## ADVISORY NOTICE

#### Water ingress to COBRA scrubber

**Figure 1 - Test equipment**

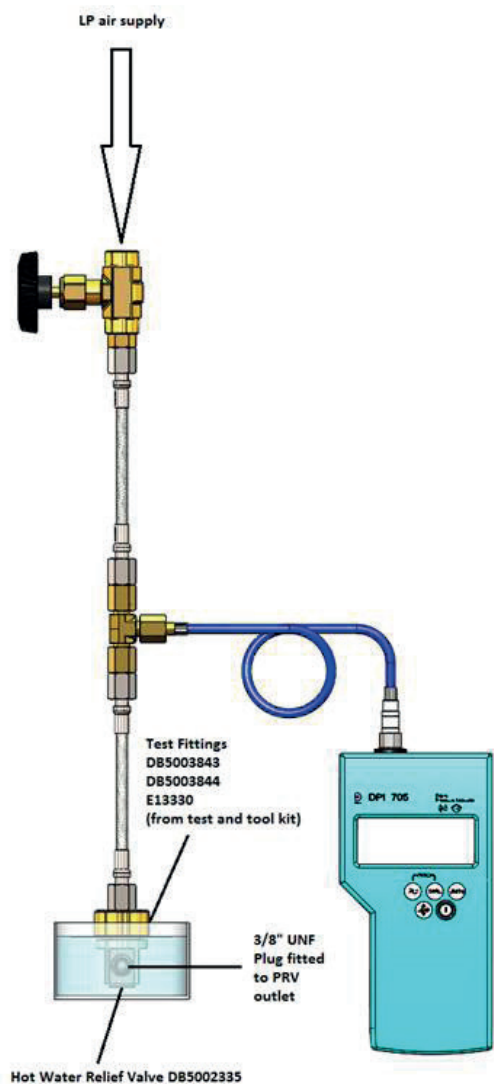
Following a thorough review and investigation of the hot water PRV, JFD recommend resetting the relief valve to open at 3 psi (rather than 4 psi as previously advised in the manual) and checking the setting fortnightly thereafter.

Fit the test plug (DB5003843), test nut (DB5003844) and o-ring (E13330) to the hot water relief valve DB5002335 as shown in figure 1. These items are contained in the COBRA Tool and Test Kit. Fit a 3/8" UNF plug to the outlet of the relief valve.

Connect an LP air supply and a calibrated LP gauge. Care should be taken when applying the pressure if a very low range gauge is used until it is confirmed that the PRV will vent correctly.

**NOTE:** Ensure that the 3/8" plug does not interfere with the spring inside the PRV. It may be preferable to fit the Hot Water Inlet Hose from the COBRA set (which has a specially shortened 3/8" fitting) and fit a 9/16" UNF blank to the other end of this hose.

Immerse the hot water relief valve in water (minimum depth to cover relief outlet).

Gently apply air pressure to the relief valve inlet and note the pressure reading when bubbles start to form in the water

**NOTE:** The reading is taken when the first bubbles begin to form. Any appreciable flow through the PRV will cause a higher reading on the gauge due to the port size on the test fitting.
